238 WEST BROADWAY (COMPLETE APPLICATION)
DE415565 - ZONE C-3A

DEVELOPMENT PERMIT STAFF COMMITTEE MEMBERS

DEVELOPMENT PERMIT STAFF COMMITTEE RECOMMENDATION: APPROVE

EAST
ELEVATION
SECTION 1

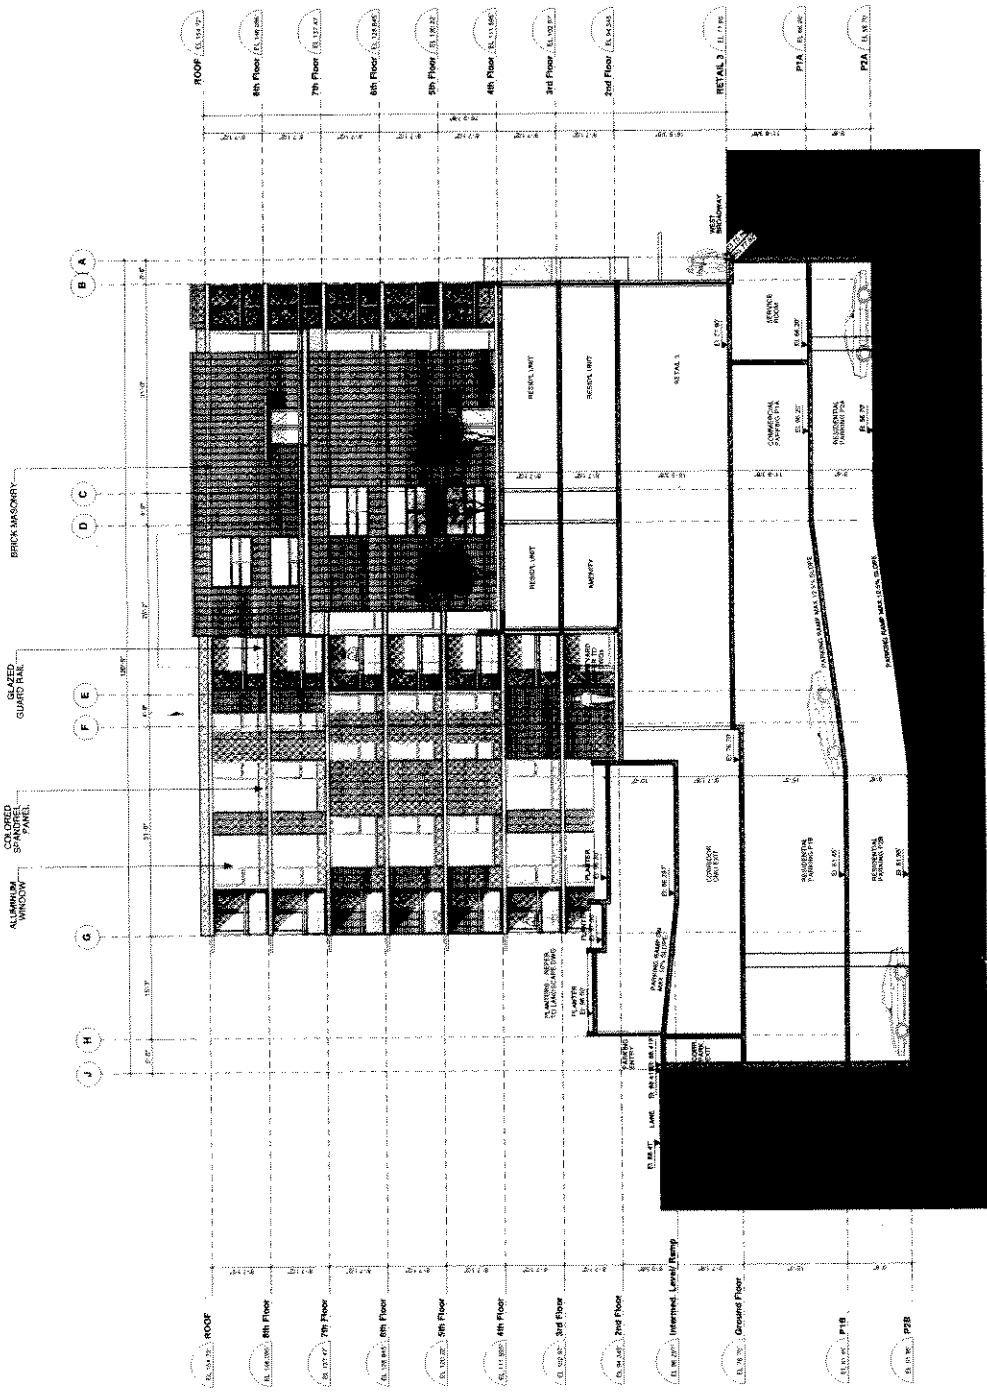
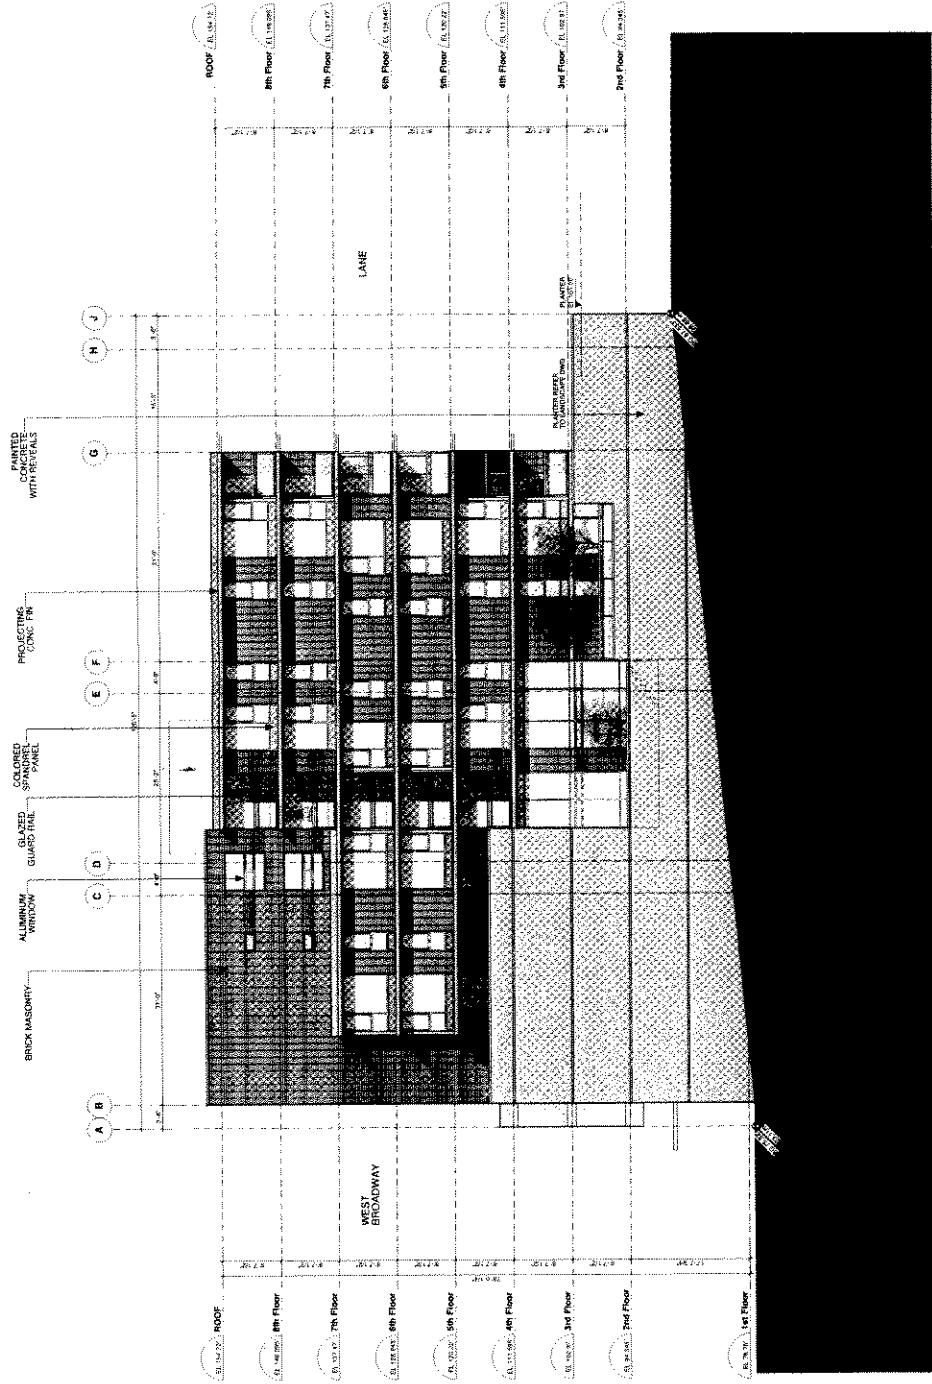
IV. East Elevation Section 1 drawing on Sheet No. A-3.03 and Intermediate Floor Plan on Sheet No. A-2.03 do not match at the underground parking entry;

Note to Applicant: Submission of revised detailed FSR overlays indicating all spaces and uses included or excluded from FSR calculations will be required. Corresponding floor areas on the overlays, floor plans, and project statistics should match.

SECTION 2

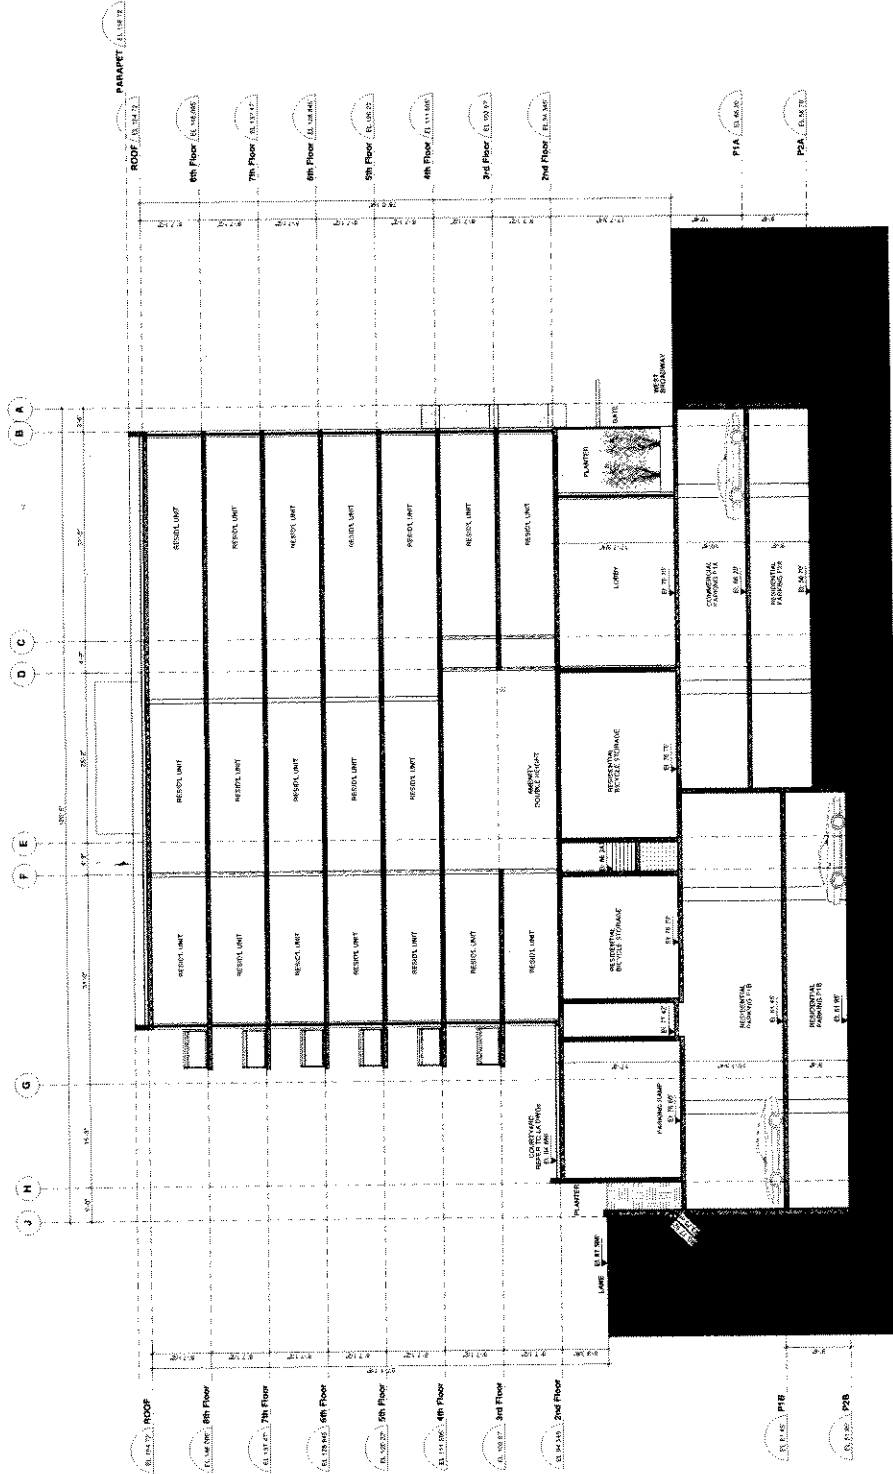
Note to Applicant: The floor levels shown on the ground floor plan and on Section 2 on Sheet No. A-3.05 do not match.

SHADOWS

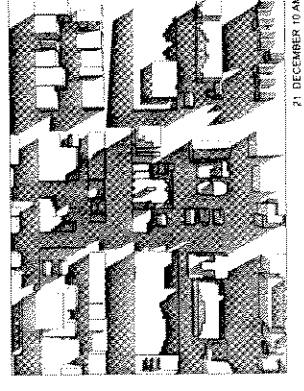
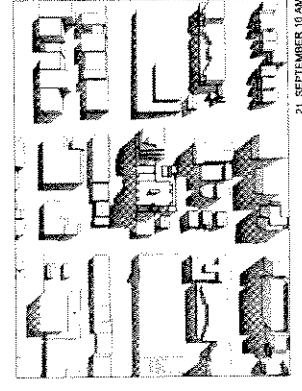
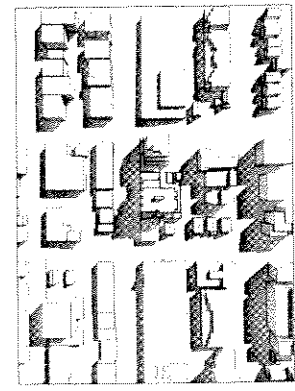
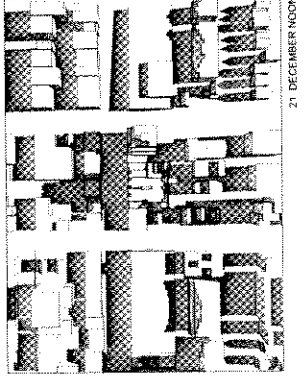
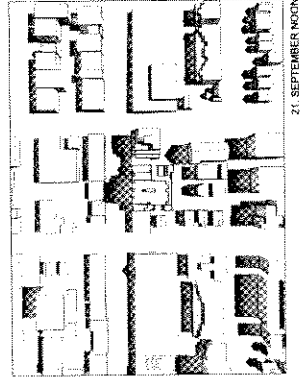
- 1.1 design development to improve sun access to the public realm, north sidewalk of Broadway, reducing shadowing by the proposed development;

Note to Applicant: This can be achieved by increasing the building setback by an additional 2 ½ ft. and by substituting glass canopies for the solid roof covers of the top floor balconies to achieve a shortened and more variegated shadow profile.
